**CITY OF ESSEX JUNCTION  
DEVELOPMENT REVIEW BOARD  
PUBLIC HEARING AGENDA (REVISED)  
SEPTEMBER 21, 2023  
6:30 P.M.**

**Subject:** 8 Railroad Street –Conceptual Site Plan Review for proposed 39-unit residential apartment building

**To:** Development Review Board  
**From:** Jennifer Marbl, City Planner  
**Meeting Date:** 09/21/2023  
**Subject:** Conceptual Plan Pearl Street Place by GVV Architects Inc., for Robert Paroline, Owner, in the Highway Arterial District for a Planned Unit Development.  
**File:** SP#7.2023

Elevations

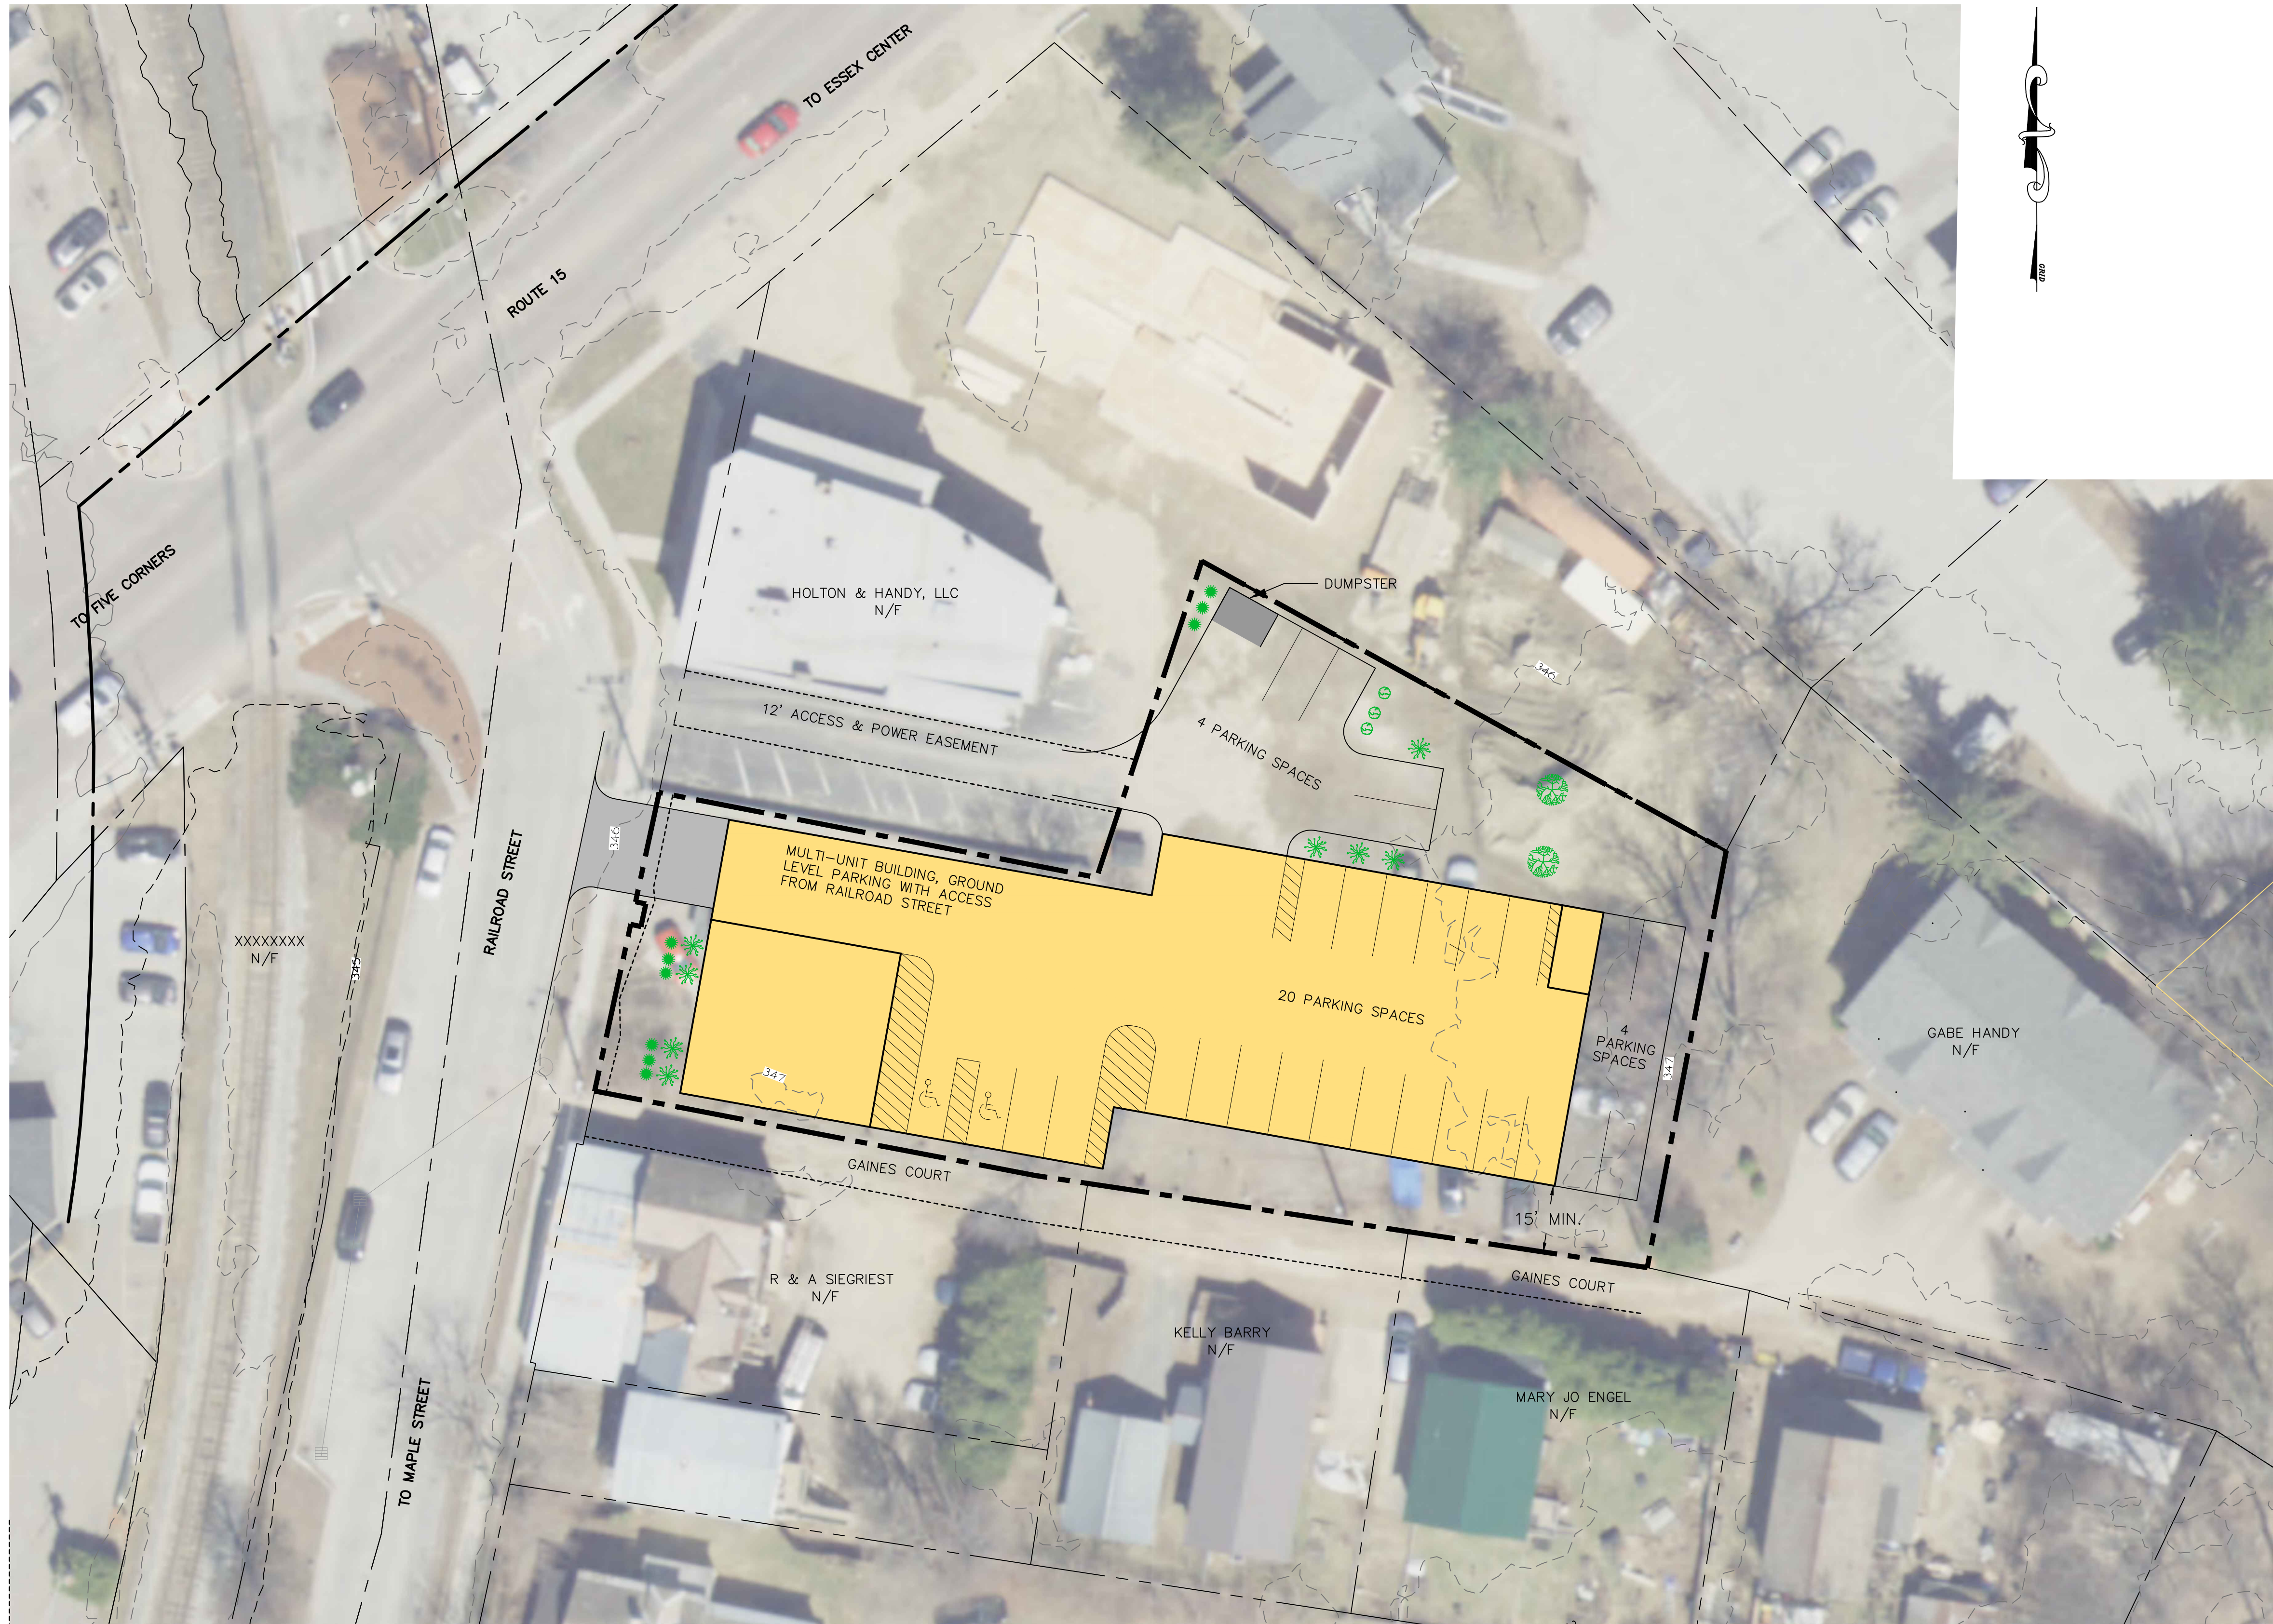
The proposed four-story building is in line with the intent of the VC District to provide for a compact, commercial center providing a mix of uses. A previous version of the conceptual site plan application included a brick façade and a flat roof throughout the entire building. The current version includes a “barn-style” façade on the front, and a brick style walls and a flat roof throughout the rest of the building. This attempts to emulate existing architecture and design in the area, although the driveway entrance through the front of the building is not a not a common feature of nearby mixed-use buildings, many of which were constructed before the automobiles became prevalent.

SHEET:  
**LS.1**

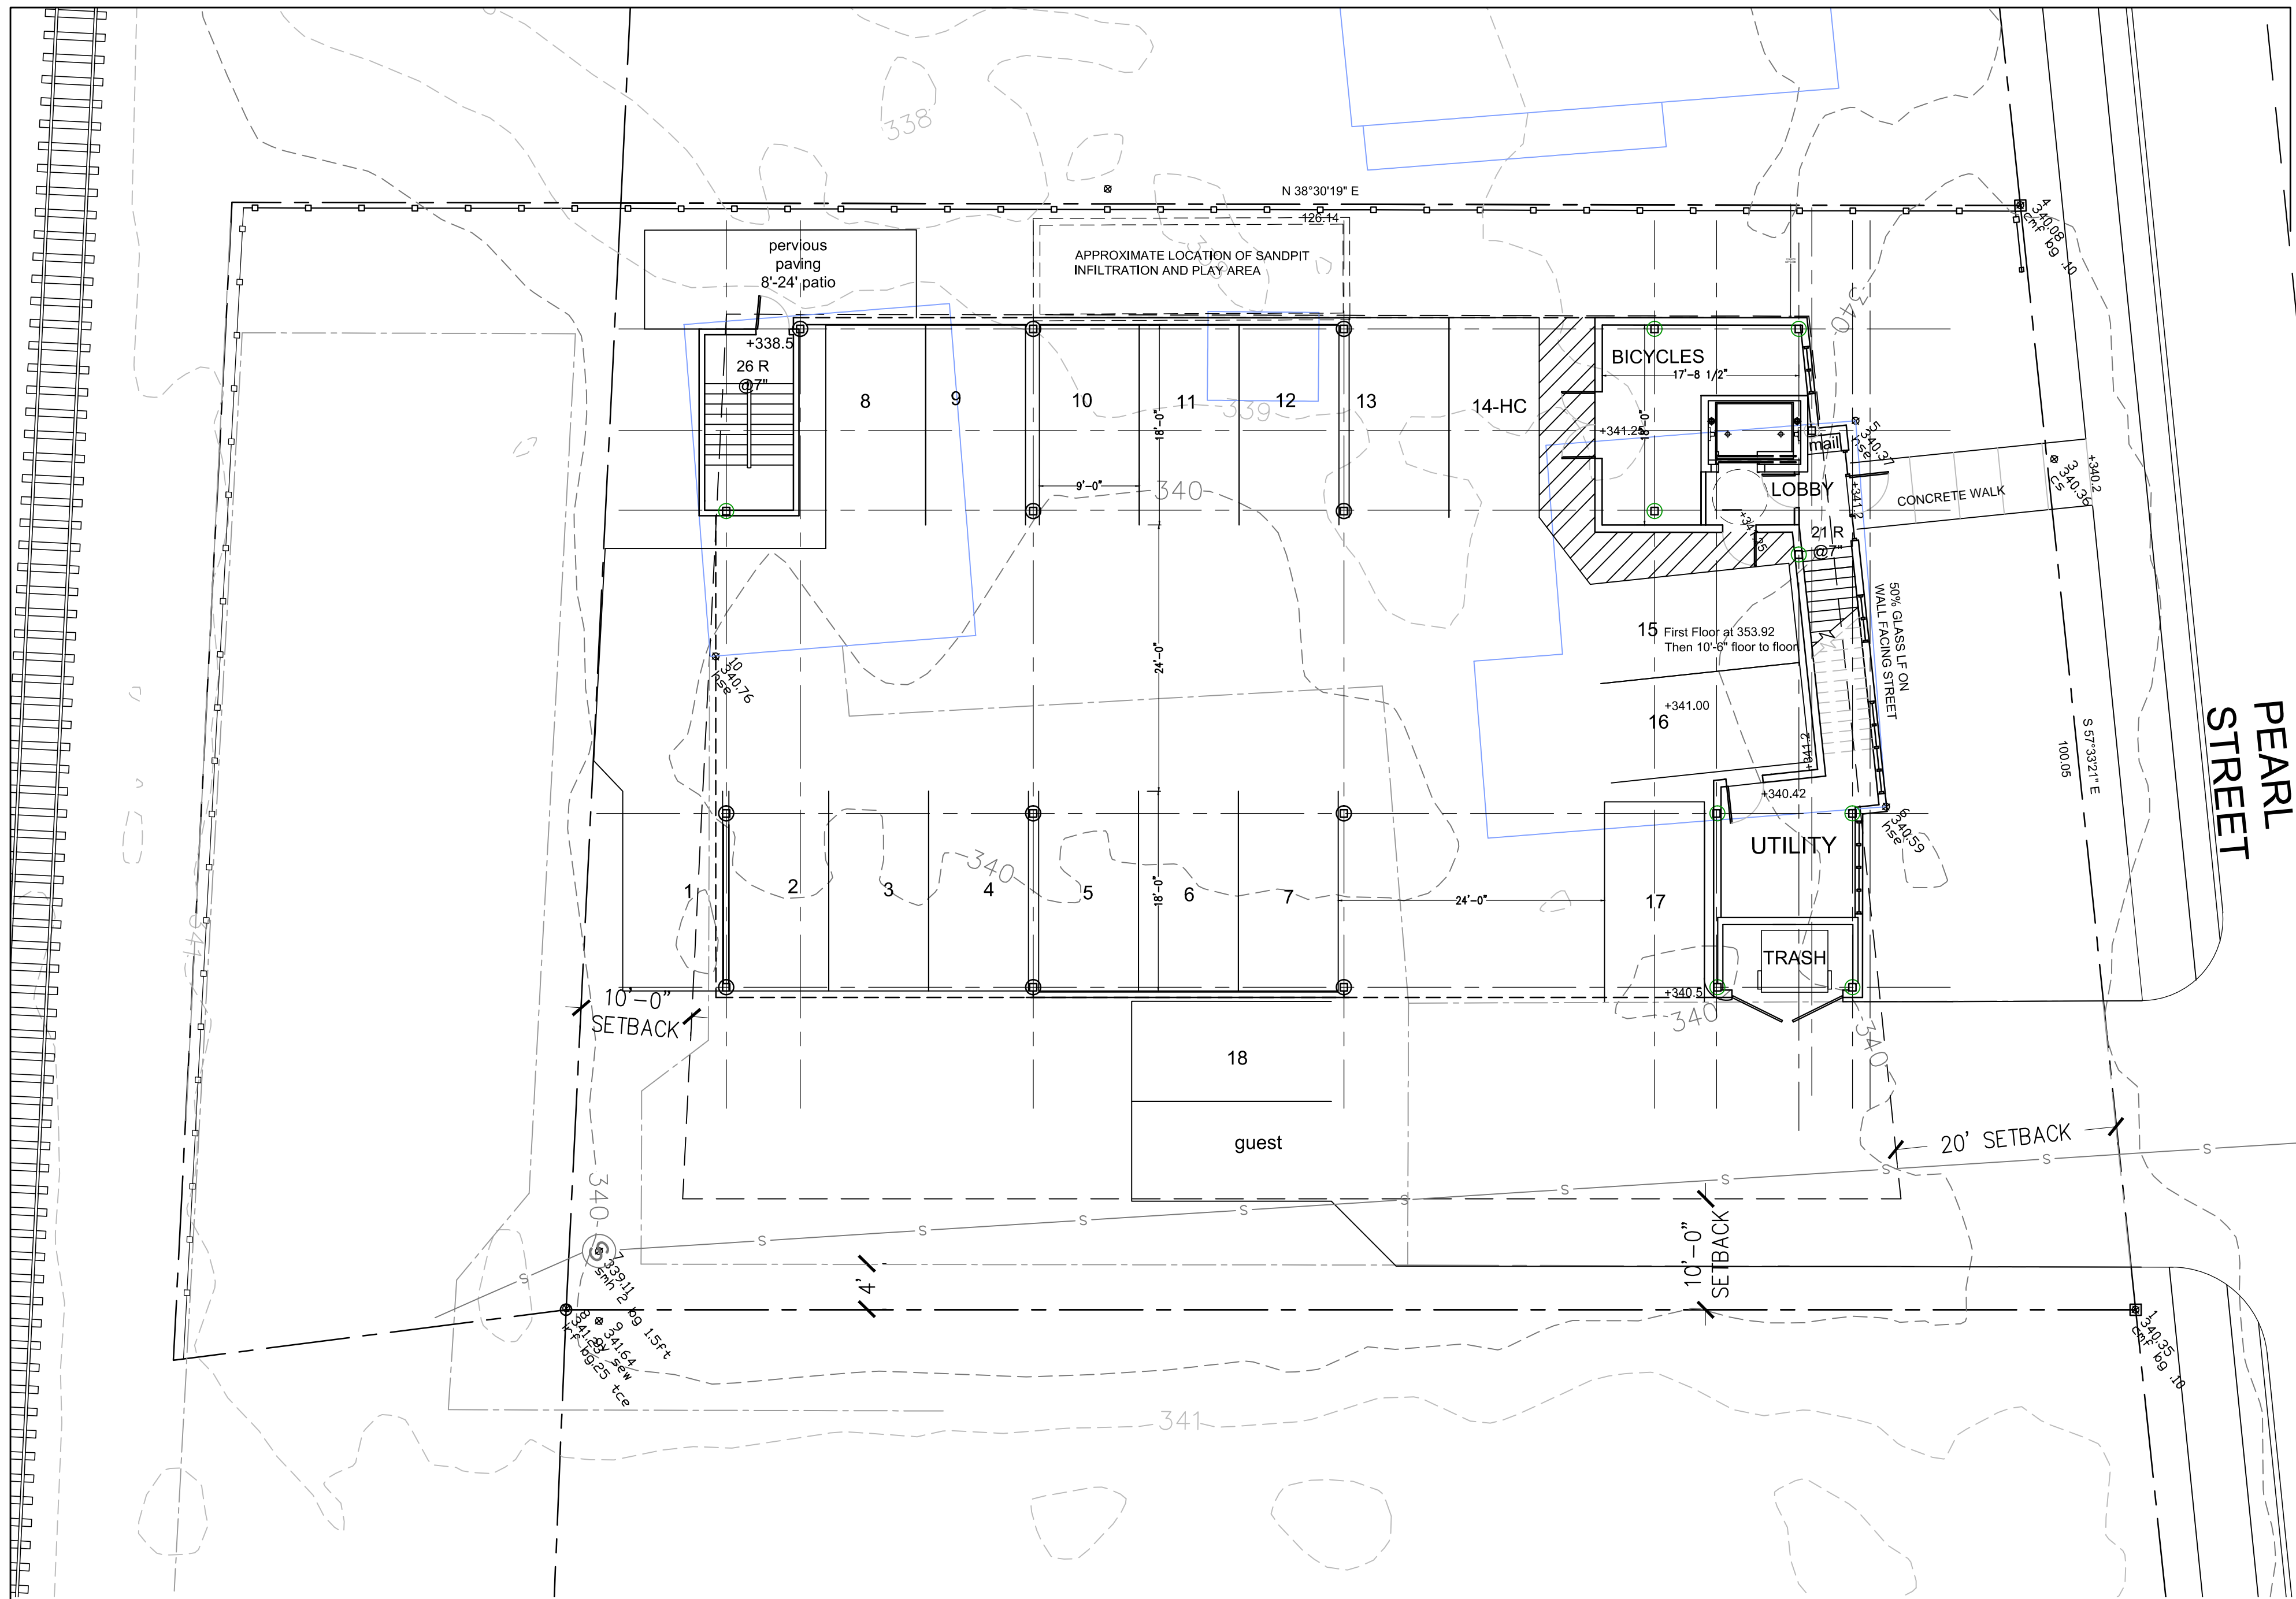
**The proposal has included a conceptual landscaping plan showing the type and location of new landscaping. This site plan lacks existing vegetation or designations for preserving any significant existing vegetation. The applicant will be required to submit a full landscaping plan during the final site plan review.**
